Amended Record of Decision
Gratwick Riverside Park Site
City of North Tonawanda, Niagara County
Site Number 9-32-060

December 1998

DECLARATION STATEMENT - AMENDED RECORD OF DECISION

Gratwick Riverside Park Inactive Hazardous Waste Site City of North Tonawanda, Niagara County, New York Site No. 9-32-060

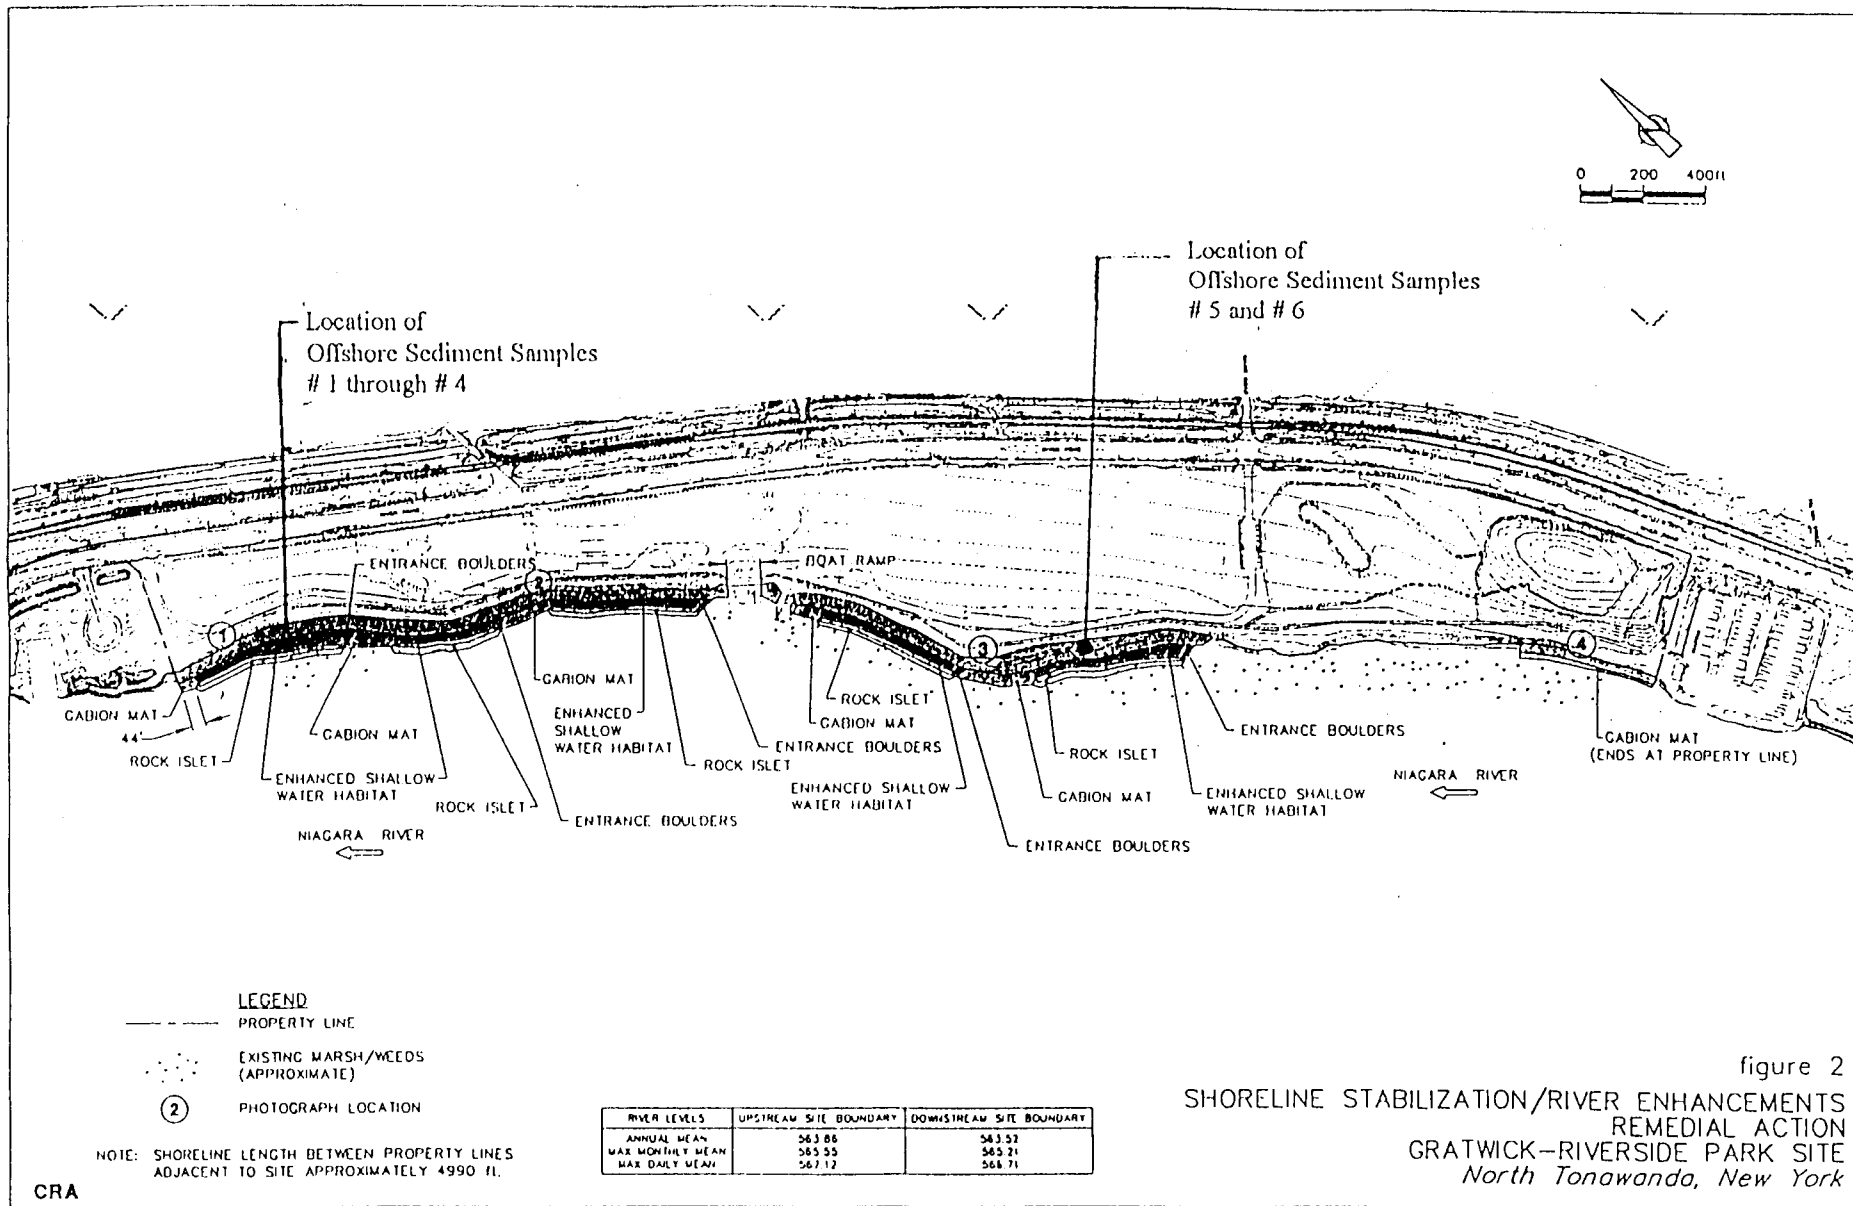
In December 1996, the NYSDEC obtained sediment samples from the Niagara River alongside the Site at six locations (see Figure 2). The analytical results from these samples (see Tables 1 and 2) were then compared with levels given in the DEC document entitled, "Technical Guidance for Screening Contaminated Sediments," (November 1993). Several contaminants were present at concentrations above the screening levels. Copper, lead, and zinc were consistently found at concentrations above the screening levels. As stated in the guidance, "Sediments with contaminant concentrations that exceed the criteria listed in this document are considered to be contaminated, and potentially causing harmful impacts to marine and aquatic ecosystems." To evaluate the significance of these potentially harmful impacts, comprehensive studies can be completed to acquire data, perform risk assessments, and ultimately predict impacts. In May 1997, the DEC proposed a Sediment Sampling and Analysis Plan

figure 3
TYPICAL CROSS-SECTION DETAIL
GRATWICK-RIVERSIDE PARK SITE
North Tonawanda, New York

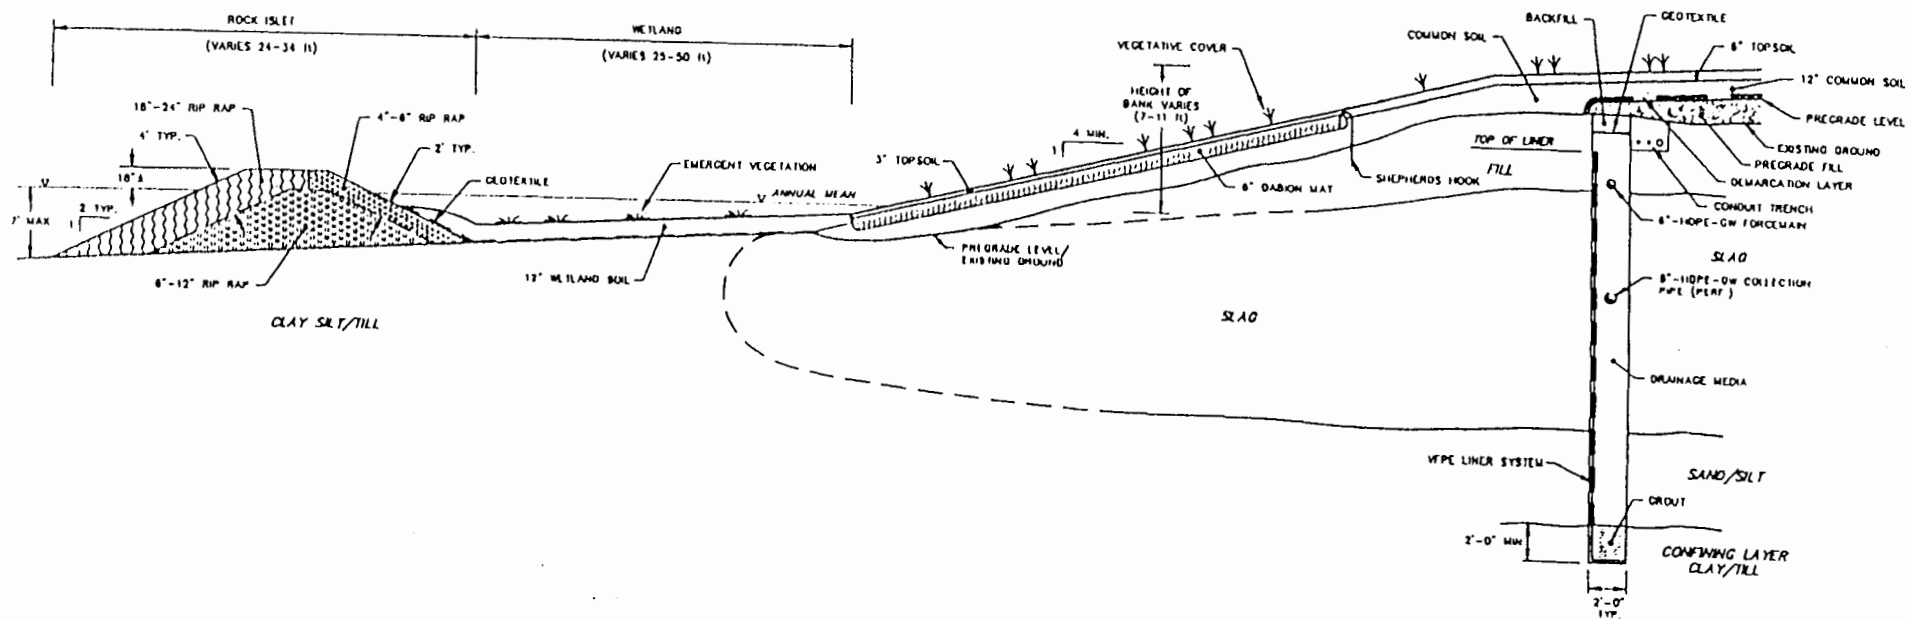
The original ROD (dated February 14, 1991) called for the installation of a sheet pile breakwater along the entire length of the shoreline, to prevent erosion of contaminated shoreline soils as well as reducing the hydraulic connection between the on-site overburden groundwater and the Niagara River. On May 16, 1996 the PPs signed an Order on Consent and agreed to design and implement the remedy. When the Scope of Work (SOW) was being developed for the design and implementation of the remedy, a review of site conditions showed that it would be difficult to install the sheetpile wall through the slag which underlies the site. Also, the sheetpile wall was not considered desirable for either shoreline habitat or a park setting. Therefore, instead of a sheetpile wall, the SOW included a clay barrier wall for groundwater control. To prevent erosion of shoreline soils, the SOW envisioned a combination of a more gradual slope and surface features (e.g. rip-rap) to minimize soil loss.

The approach to stabilizing the shoreline underwent further review during the actual design. Disturbance of the shoreline or the river during construction must comply with regulations administered by Department and the U.S. Army Corps of Engineers (ACOE). To comply with the intent of these regulations, which are independent of any sediment contamination issues, a proposal was developed that would stabilize the shoreline as well as protect and improve habitat values along the shoreline of the site. This proposal had the added benefit of addressing the sediment contamination discovered since the original ROD. Specifically, rock islets (rock-mound breakwaters) will be installed along the length of the river at a distance ranging from approximately 50 to 100 feet from the edge of the water line at the shore (see Figure 3). All sediments (whether contaminated or not) between the shoreline and the rock islets will be covered with a minimum of 12" of hydric soils (saturated soils that supports wetland

vegetation). Sediments will be covered with 6" of hydric soil and 9" of gabion mattress in areas where rock islets are not included. The New York State Office of Parks, Recreation and Historic Preservation is currently involved in a Rehabilitation Project at the Buckhorn State Park. The Buckhorn Project was permitted by the NYSDEC and US ACOE to allow the dredging of the soils within the marsh for identified beneficial uses. Buckhorn dredged soils can be made available to the City of North Tonawanda for use as the hydric soil for creation of the wetlands. The shoreline will be covered with 12" of common soil, 6" gabion mattress and 3" top soil. Exposed competent slag exists for about 1000 feet near the southern end of the site. All construction and demolition debris and waste material between the barrier wall and the river above competent slag will be removed from this area. The competent slag in this area will not be covered.

The sloped bank will be protected with rip-rap gabions and rock islets along the shoreline. During final design, two types of barrier walls (Bentonite slurry wall and High Density Poly Ethylene (HDPE) wall) were evaluated by the design consultant. Based on this evaluation the HDPE wall was selected.
